4M Change Information Notice

Nesscap IN Number	IN-PJ-75-753-17003
Date of Publication	Sept. 13, 2017
Type of Change	Change in Rubber Bung

EDLC - Small Cells	XP 2.7V-3F	ESHSR-0003C0-002R7UC
	XP 2.7V-6F	ESHSR-0006C0-002R7UC

1.8 Attachments

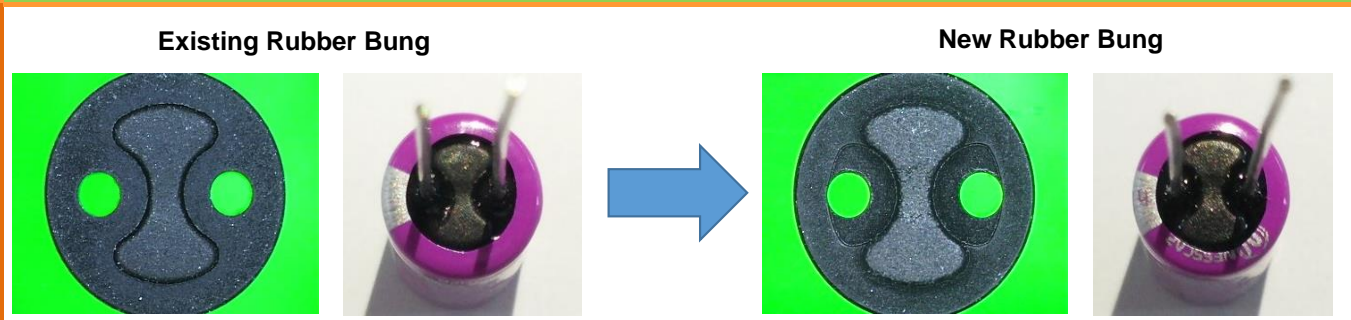
The rubber bung used for the affected products was redesigned to improve overall urethane potting process and quality.

Potting pocket was created around each terminal hole to ensure that the potting solution spreads and covers only the required area in accordance with the Nesscap potting standard. Please refer to the images in Section 1.8.
